**RECORD OF DECISION
AREA OF CONTAMINATION A4
AND AREAS OF CONTAMINATION A7 AND A9
MANAGEMENT OF MIGRATION OPERABLE UNITS
U.S. ARMY SUDBURY ANNEX
MIDDLESEX COUNTY, MASSACHUSETTS**

SEPTEMBER 1997

**RESPONSE TO COMMENTS BY
CAMBRIDGE ENVIRONMENTAL, INC.
PREPARED ON BEHALF OF FOUR TOWN FOCUS
DATED JUNE 23, 1997
CONCERNING THE PROPOSED DETERMINATION OF NO FURTHER ACTION AT
AREA OF CONTAMINATION A7**

AREA OF FIGURE 2-2

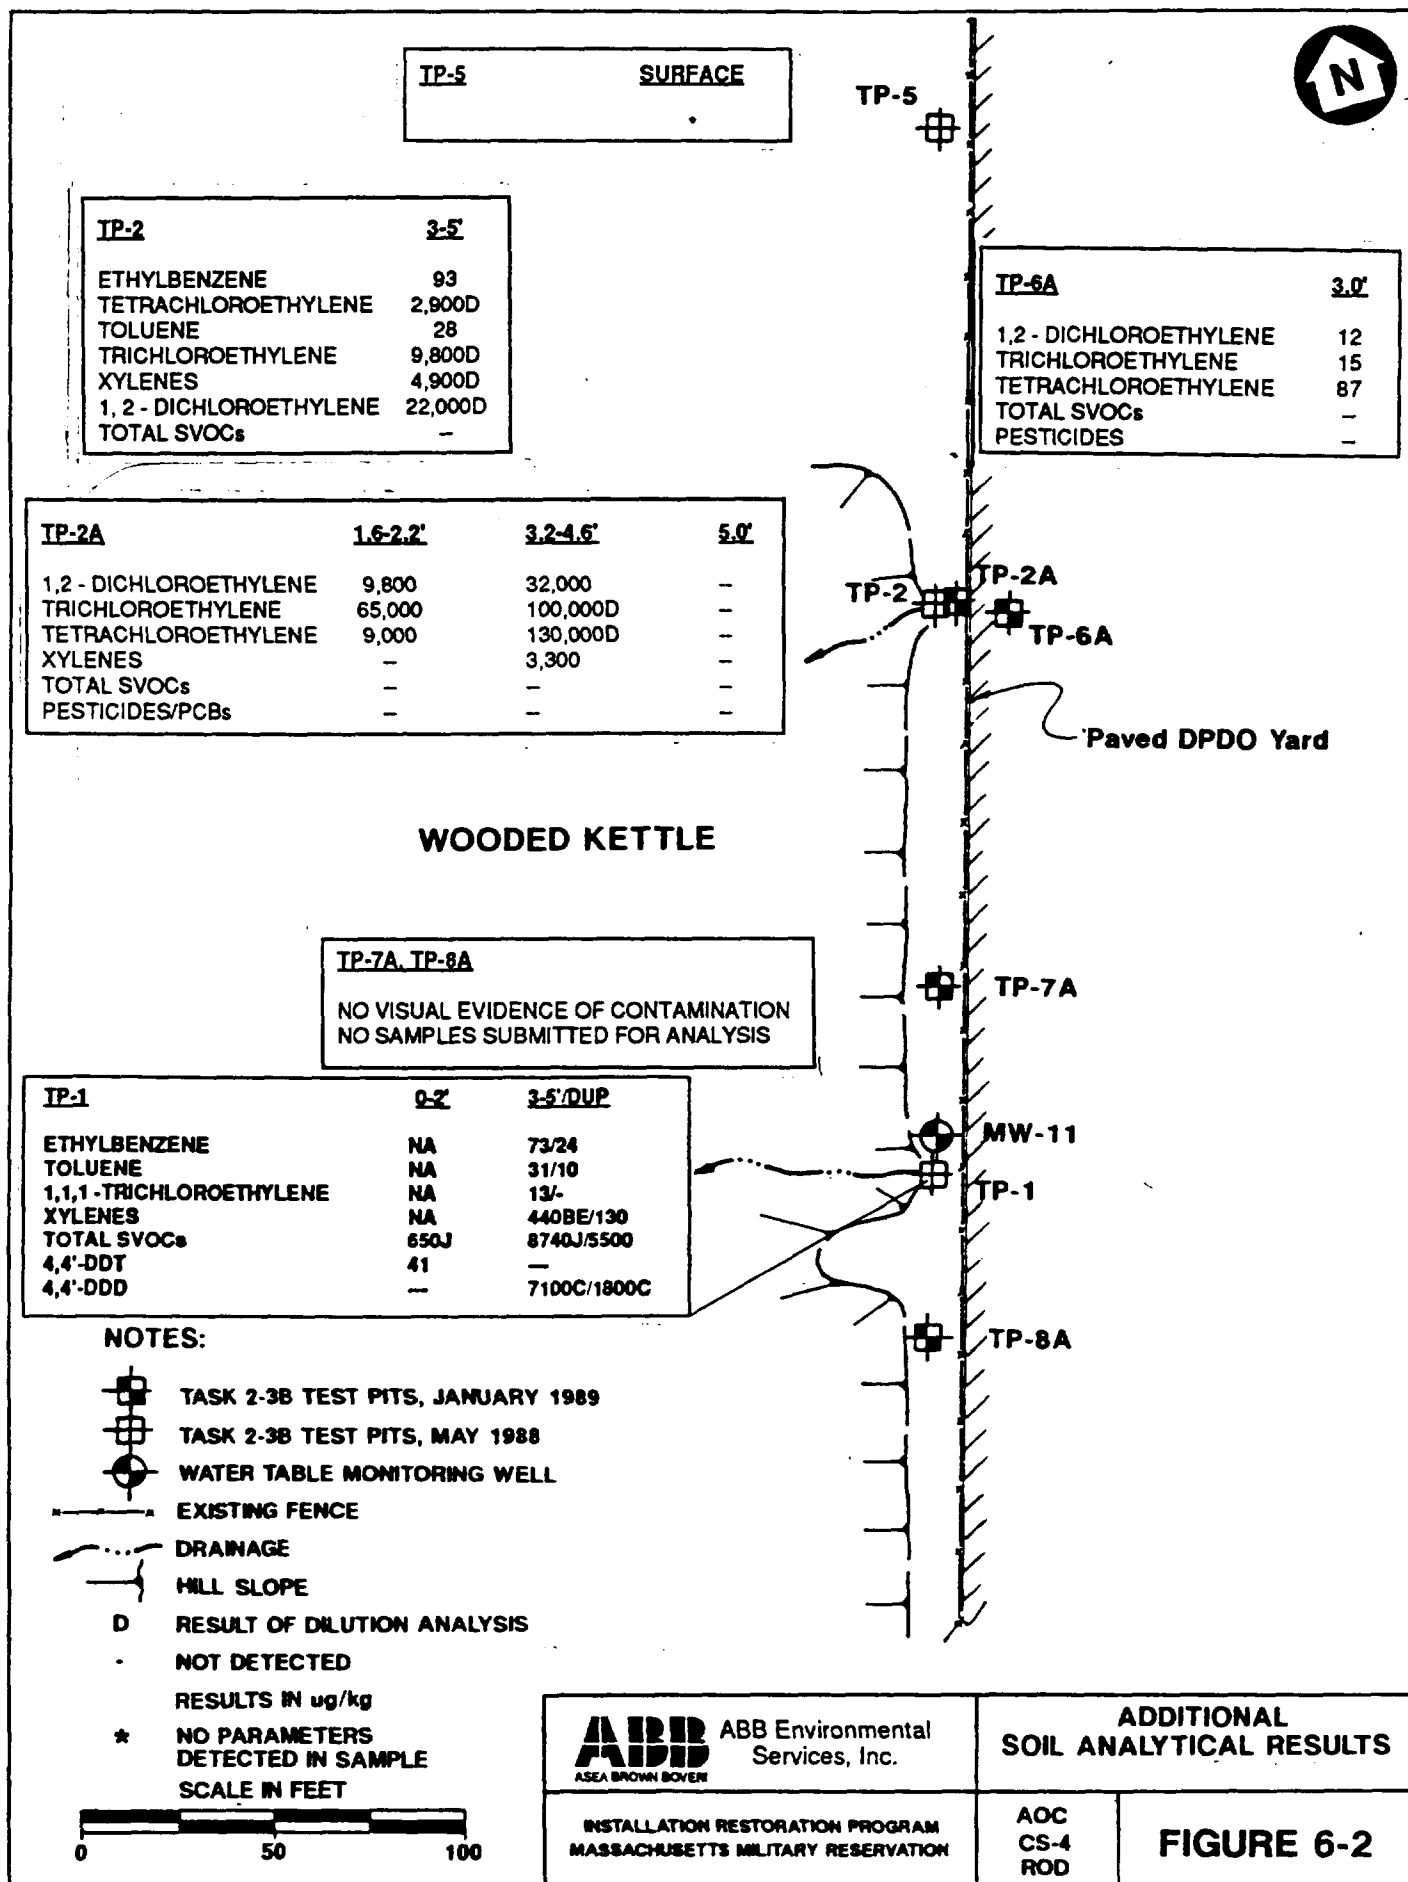
Figure 1-2, the map of the CS-4 groundwater plume, indicated "Note: Plume boundary is delineated based on 1989 groundwater data". Given the rate of groundwater movement in the area and the scale of the map, the toe of the plume would be approaching Route 151 (with Coonamessett Pond close at hand). However, this has been disputed by the ANG spokesman, who indicated that there is no evidence of pollution in recent monitoring wells' samples. The following questions need to be addressed:
